Delegated Report		Analysis sheet		Expiry Date:	25/11/2022
		N/A / attached		Consultation Expiry Date:	11/12/2022
Officer				Application Number(s)	
Sam FitzPatrick				2022/4190/P	
Application Address				Drawing Numbers	
Crestview 47 Dartmouth Park Hill London NW5 1JB				Please refer to decision notice	
PO 3/4	Area Team Signature	C&UD	Authorised Officer Signature		
Proposal(s)					
Installation of telecommunications equipment (6 x antenna apertures, 1 x transmission dish, and 7 x equipment cabinets) to the roof of existing building and ancillary development thereto.					
Recommendation(s):		Refuse Planning Permission			
Application Type:		Full Planning Permission

Figure 1: Proposed Elevation A (extract taken from drawing 265-A MAX CONFIGURATION ELEVATION Issue C)

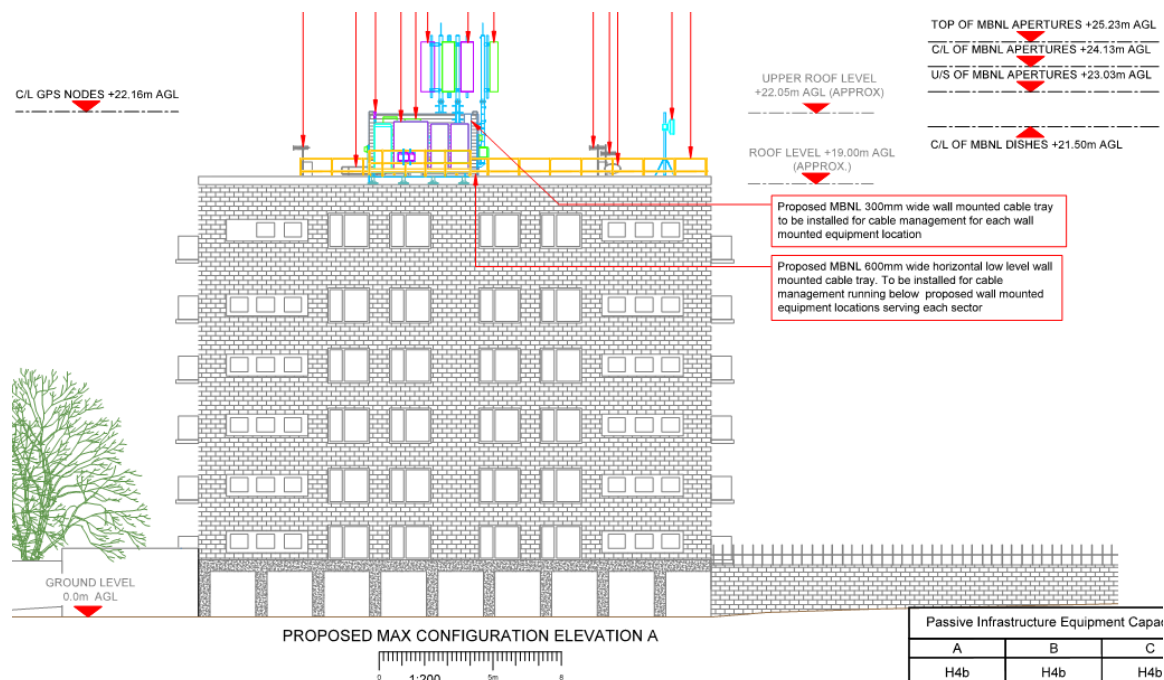
- 1.3. The roof area of the host building consists of a main flat roof space measuring 19m in height above ground level with a plant room positioned centrally. The plant room also has a flat roof measuring 22.05m in height above ground level. A roof parapet rises 0.3m above the main roof level. The submitted drawings are shown below (Image 1) and show a number of existing satellite dishes and aerials. This appears to be inaccurate, as the rooftop is absent of any telecommunications equipment, a matter highlighted by several consultation responses from residents who state that the roof is absent of dishes or aerials of any kind.

- 1.4. The 6 x proposed antennas would be mounted in pairs on three mounting poles and located in a cluster around the plant room, which they would all be fixed to the walls of. The drawings show the top of the antenna to measure 6.23m above the height of the main roof and 3.18m above the height of the plant room, which the antennas are wall mounted against. The top of the wall mounting structure would rise a further 0.82m approximatively above these heights (7.05m above the main roof and 4m above the plant room roof).
- 1.5. 1 x proposed dish would be installed and mounted on a freestanding frame at the southeast edge of the main roof. The top of the dish and supporting frame would measure approximately 3.10m above the height of the main roof.

Figure 3: Aerial view of Crestview and proposed siting of equipment

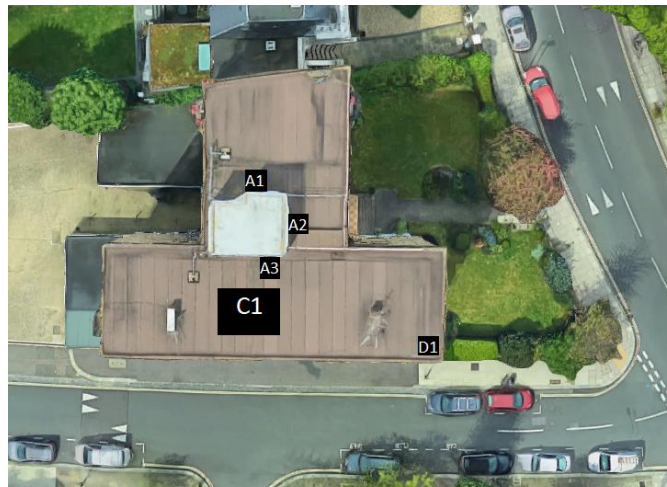
3.6. Crestview and the immediately surrounding area are shown below in Image 2, with the four elevations shown by the drawings clearly labelled. Below that, Image 3 shows the roof with the approximate positions of the 6 x proposed antennas, the 1 x transmission dish, and the area contained the 7 x rooftop equipment cabinets. The antennas (there are 2 x antennas in each shown area) are indicated by A1, A2, and A3, the dish is indicated by D1, and the area containing the cabinets is indicated by C1.

3.7. The application site of Crestview is located at the top of Dartmouth Park Hill, so is highly visible from a number of different directions, as shown by the images 1-4 below. The building itself is also substantially taller in comparison with neighbouring buildings in the surrounding area, which are mostly lower-level residential properties. The only building that is a similar height is St Mary Brookfield, a Grade II* listed church immediately adjacent to the south of the site. Section 3 details the impact of the proposal on the church and its setting. The location, siting, and scale of the host building emphasise its prominence within the area, skyline, and numerous views.
